WEST END REGIONAL NAVIGATION CENTER PROJECT
BID NO.: DE-26-222-SB

Addendum No. 2 Information
June 16, 2026

4.1 **Revised** "WEST END REGIONAL NAVIGATION CENTER" Plan Sheets are hereby included and shall replace the previously released "WEST END REGIONAL NAVIGATION CENTER" Plan Sheets. Changes to Plans include:

A-2.1

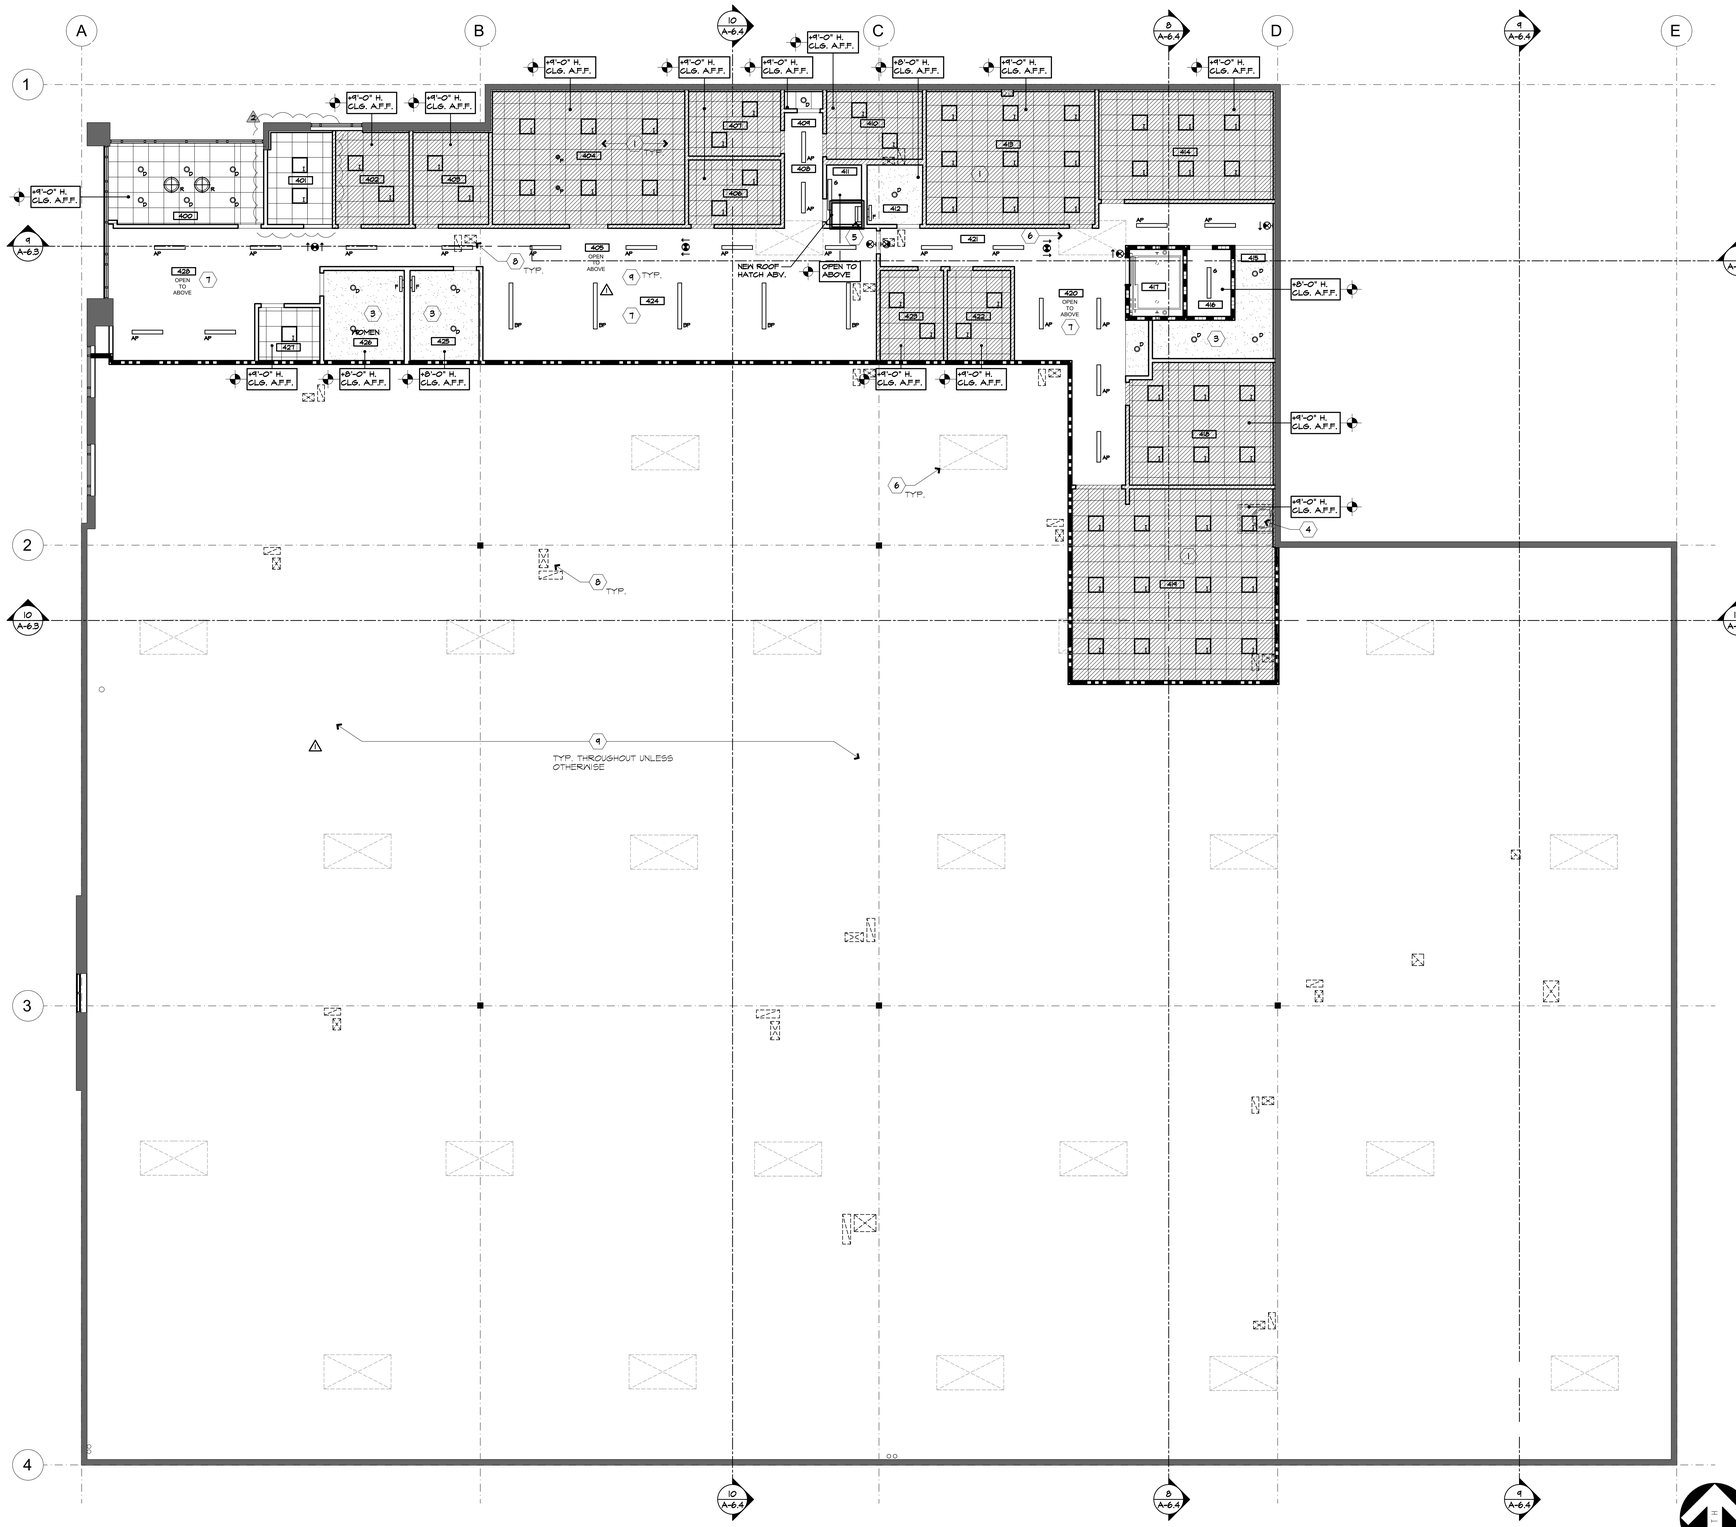
x. **Sheet A-2.1:** Clarify reconfigured west stair and ceiling. Clarify reconfigured south dorm rooms, omit exit signage at deleted doors. Omit exit sign at Room 171 deleted exit door. Indicate Room 210 as designated Mobility Dorm Room; add General Note No. 12 for Mobility Dorm Room. Requirements for fire alarm, door signal device, and audible signal device requirements. Add new keynote 11 for designated Mobility Dorm Room. Add plan note No. 12 to indicate gyp board soffit at west stair.

A-2.2

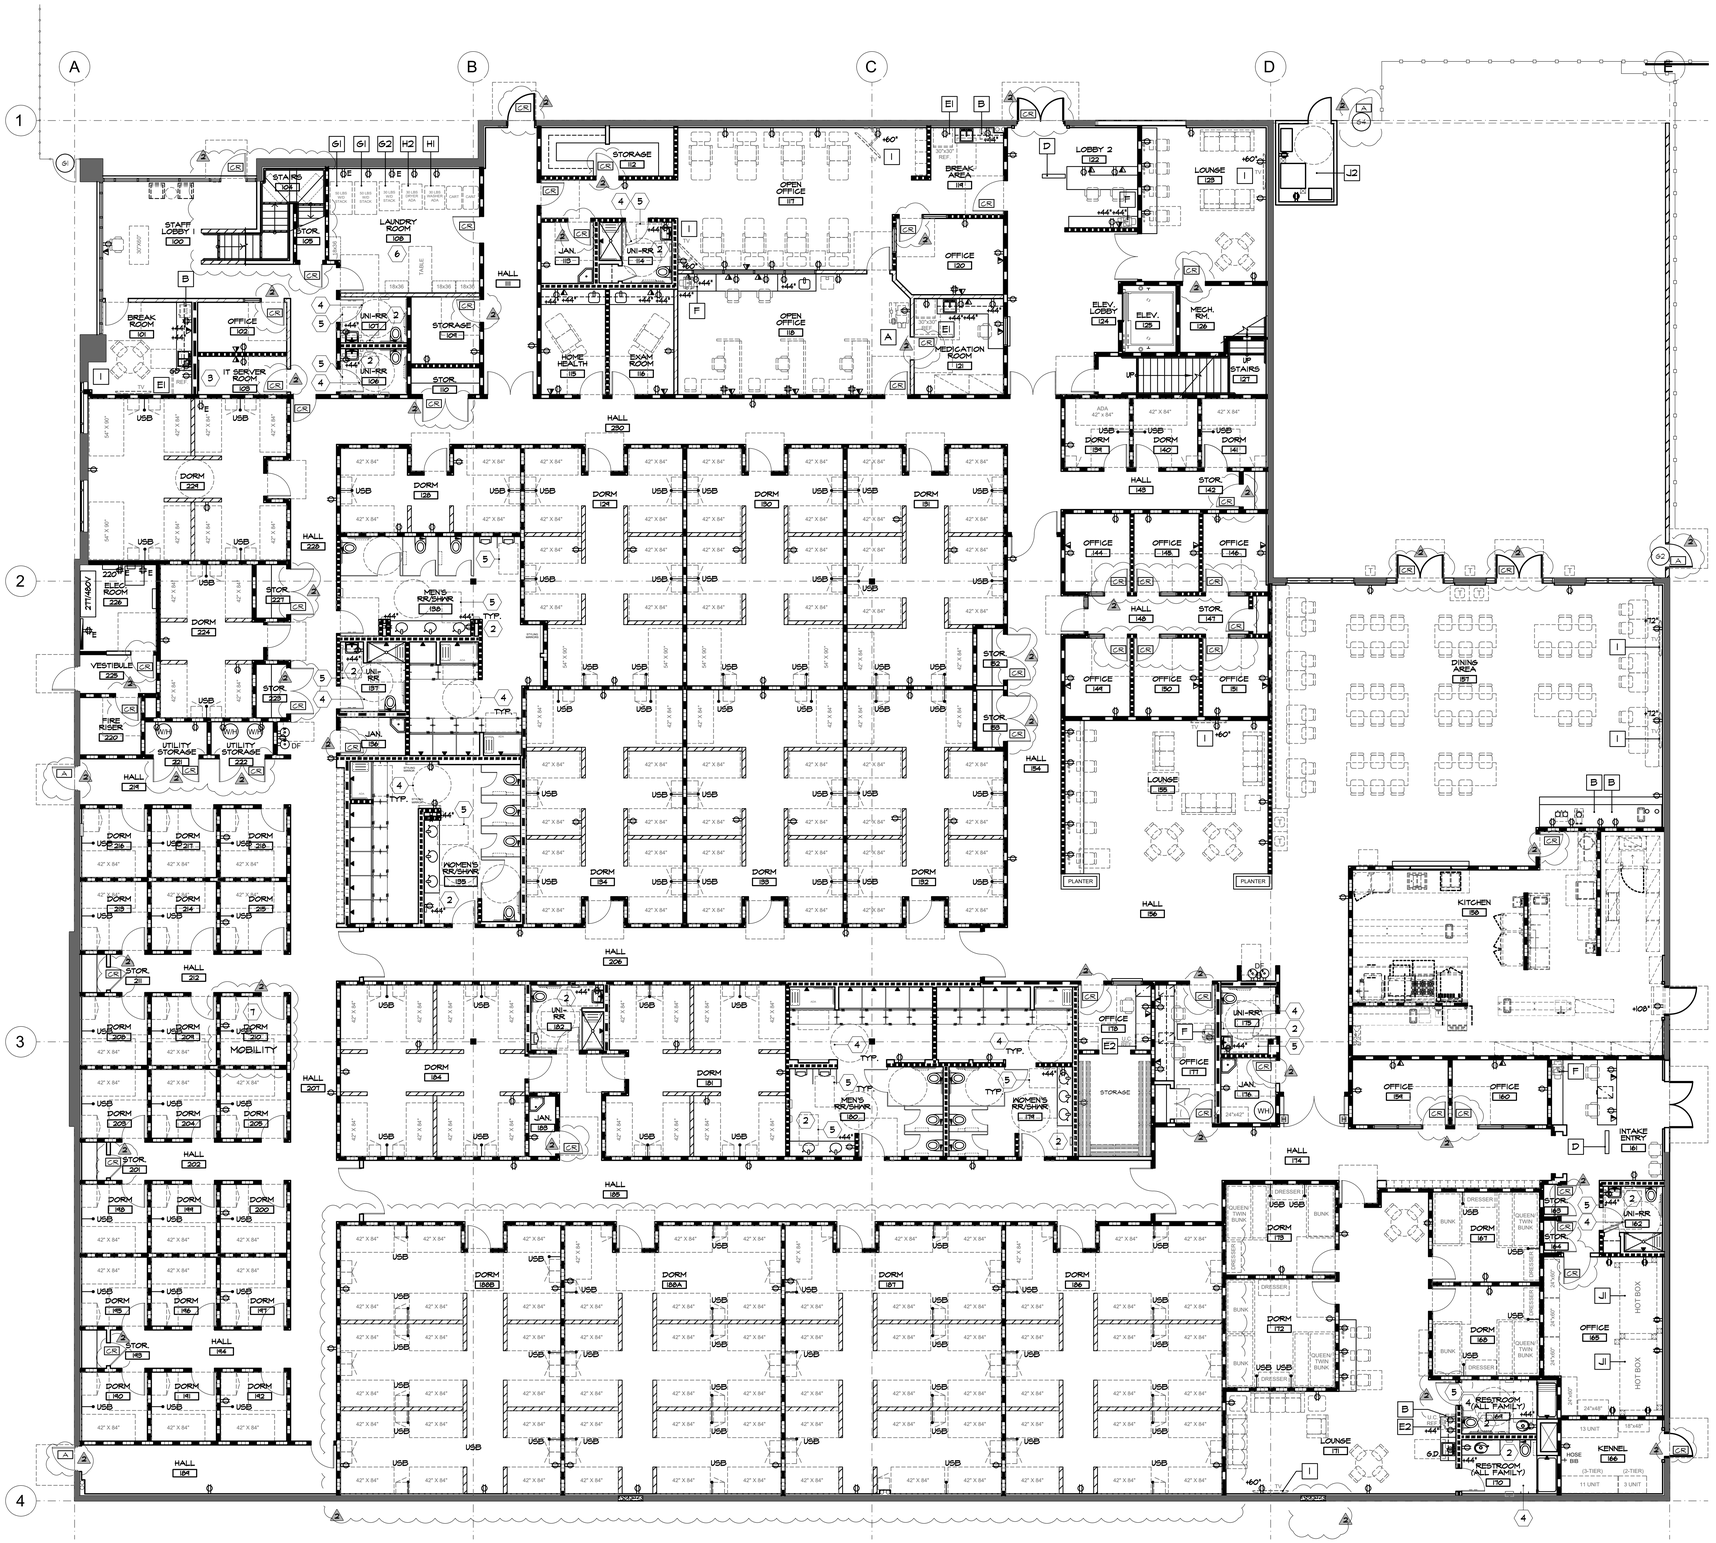
y. **Sheet A-2.2:** Clarify reconfigured West Stair.
z. **Sheet A-3.1:** Clarify card-reader locations at doors throughout. New West Stair configuration. Clarify South Dorm Room area reconfiguration; revise electrical outlet locations, etc. Clarify Room 210 as designated mobility dorm room; add General Note No. 9 for room requirements and compliance features. Clarify door-alarm locations throughout.
aa. **Sheet A-3.2:** Clarify card-reader locations at doors throughout. Clarify reconfigured West Stair.
bb. **Sheet A-4.1:** Clarify Finish General Note No. 10 for TCNA method/specification locations. Paint specification locations clarified. All Paint, Wall tiles, and wall murals have been identified on the Finish Floor Plan. Staff Lobby 100: Identify WM-4 wall mural location. Dining Area 157: Revised paint (P-2) location. Lounge Area 123: WM-5 has been added to the north wall. Intake Entry 161: revise P-2 and P-8 paint locations. Finish General Notes: General Note 15 has been added. General note 16 has been added. Finish Plan Key Notes: Clarification on Keynote #9. Finish Legend: B-1, clarify base color. FRP-4, add note to apply division bar between panels. WM-1, WM-2, WM-3 & WM-4. Wall Murals have been Specified. WM-5 Has been added to the legend. PL-6 Plastic Laminate has replaced Color Core CC-1. WT-8 Wall tile color has been revised. WT-10 Wall tile color has been revised. TP-1, Toilet Partition color has been identified. SP-1, Shower Partition color has been identified.

A-4.1

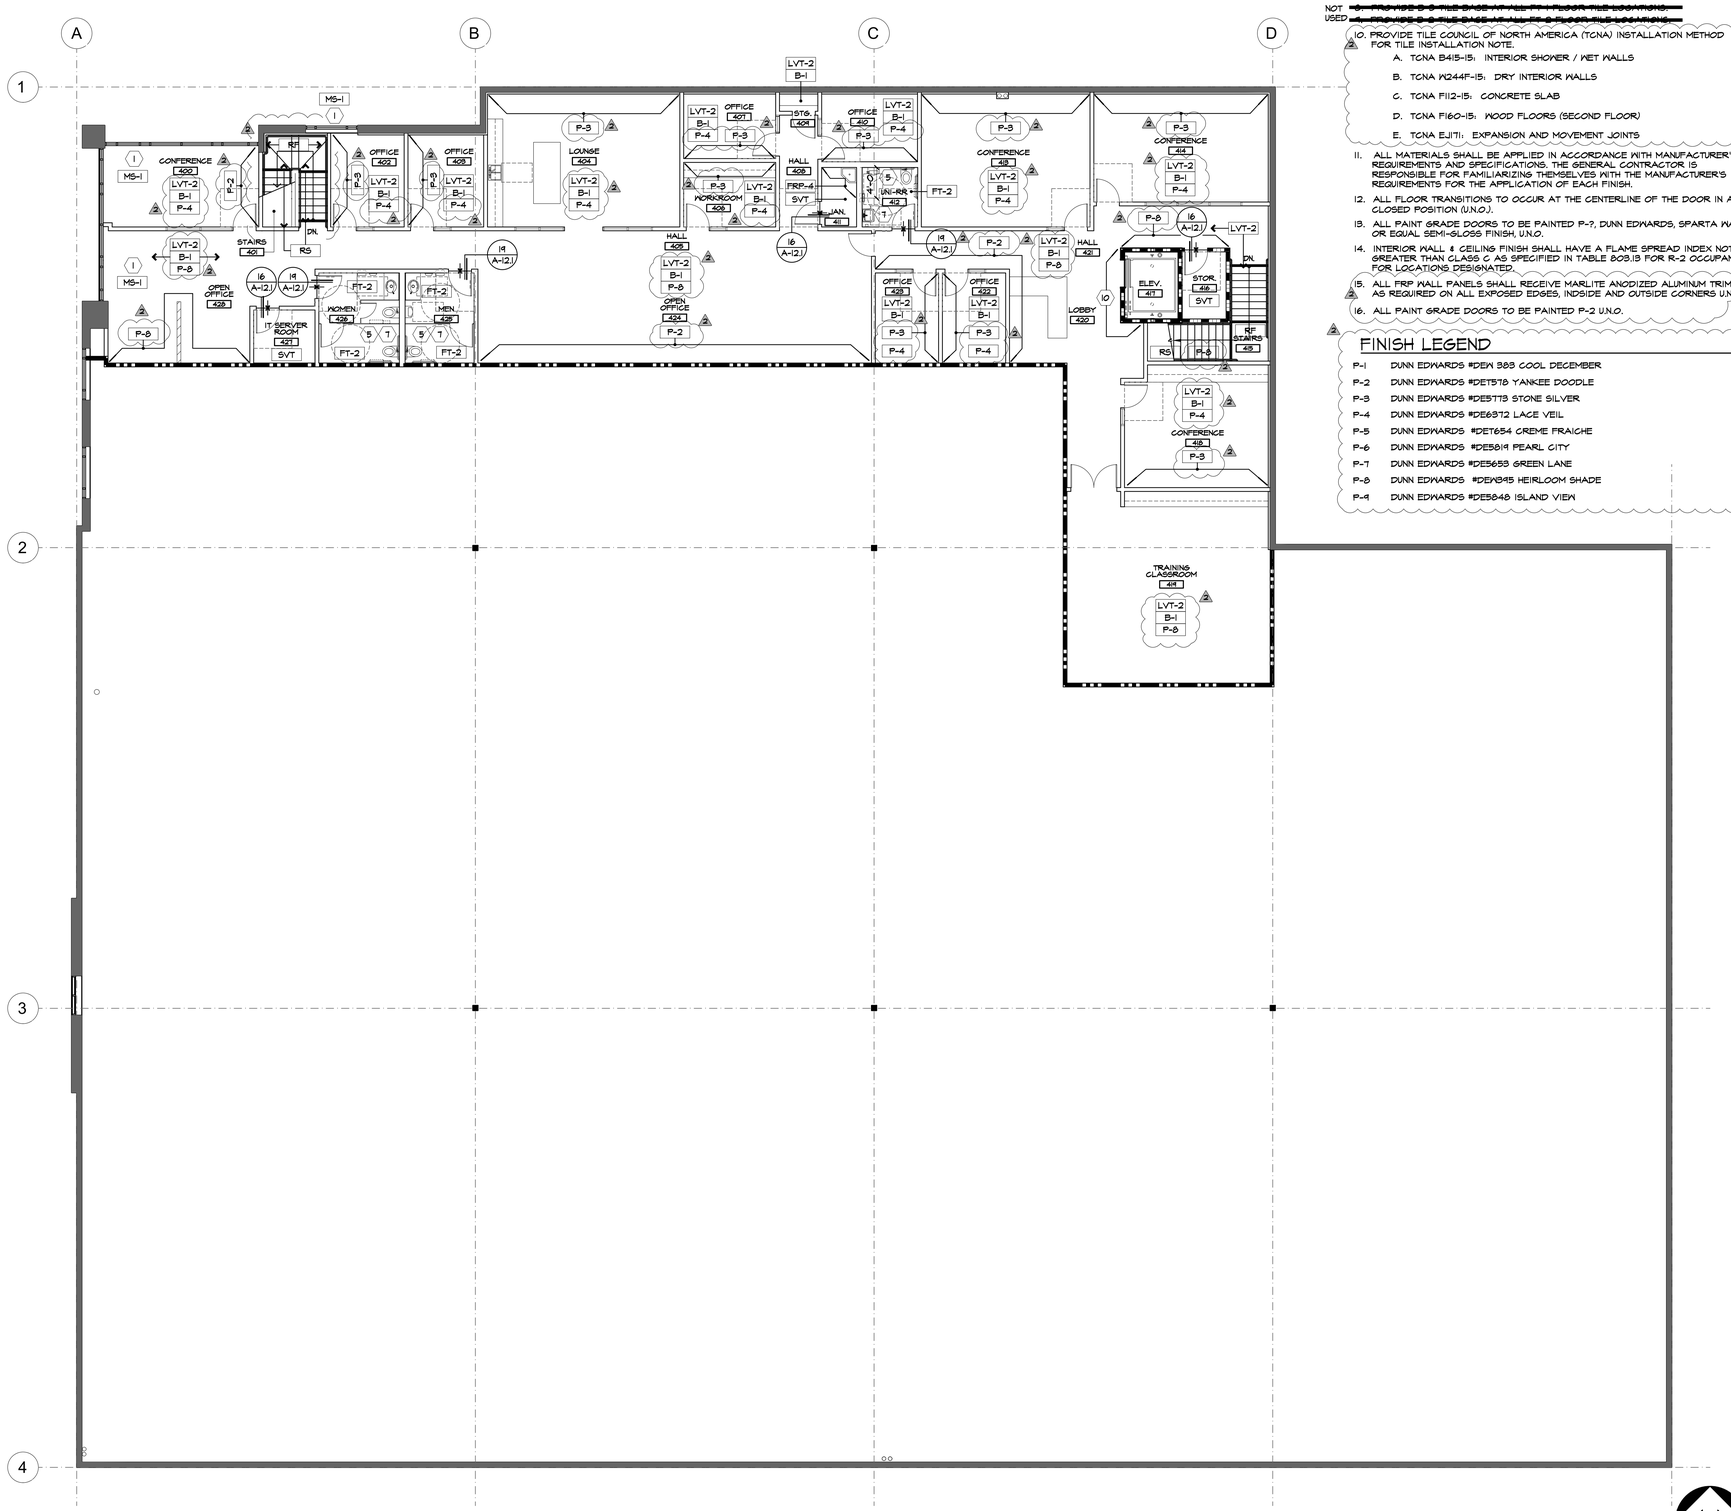
cc. **Sheet A-4.2:** Clarify Finish plan General Note No. 10 for TCNA method/specification locations. Paint specification locations clarified. General:

A-4.2

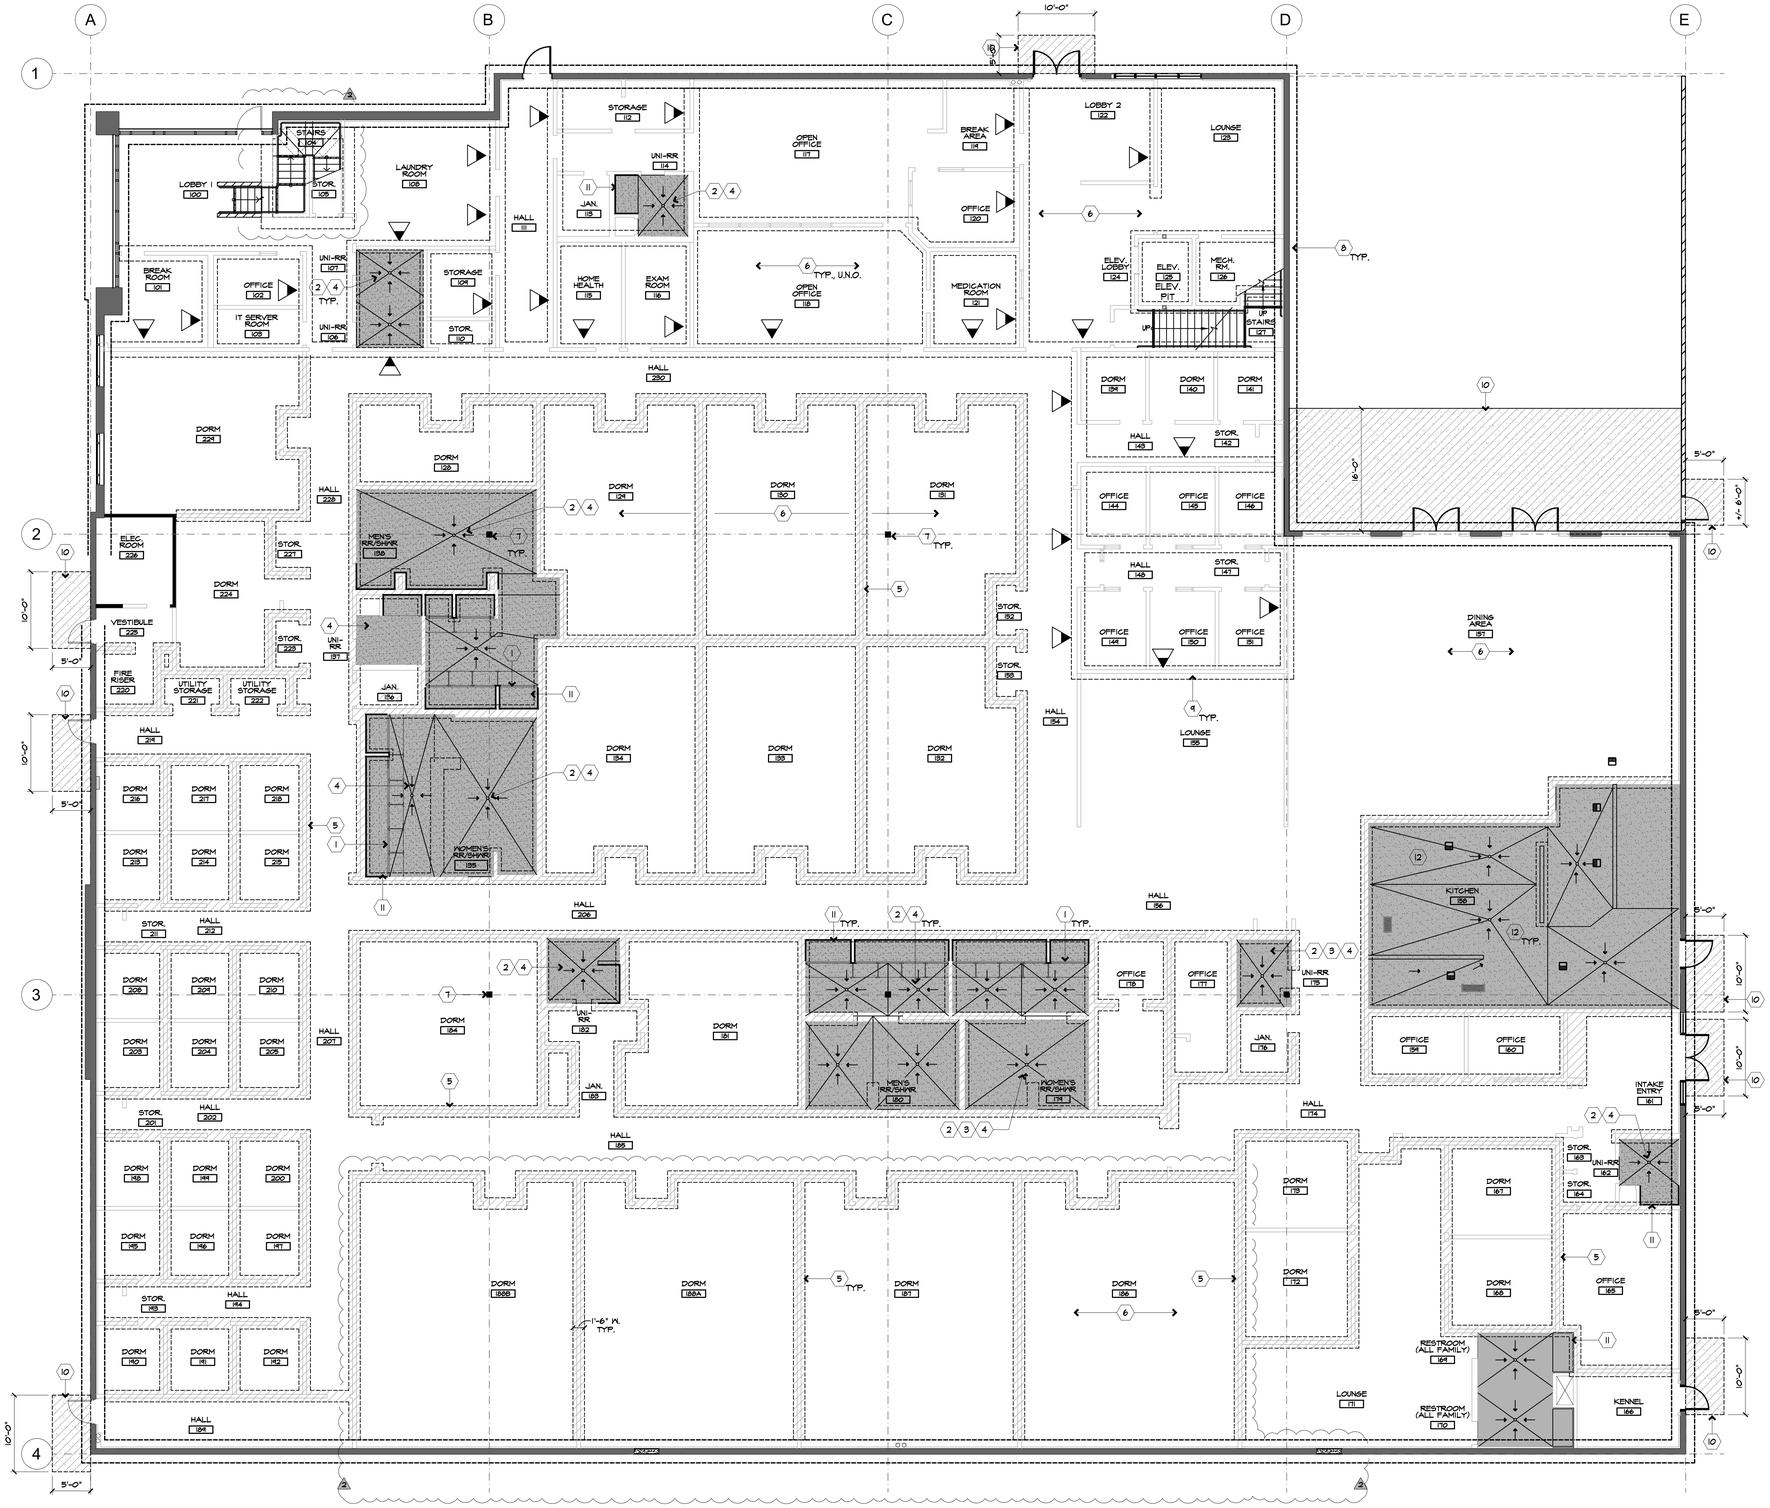
dd. **Sheet A-4.3:** Clarify south dorm rooms, footings, etc. Omit south exit door landings at reconfigured dorm room area. Clarify west stair reconfiguration.
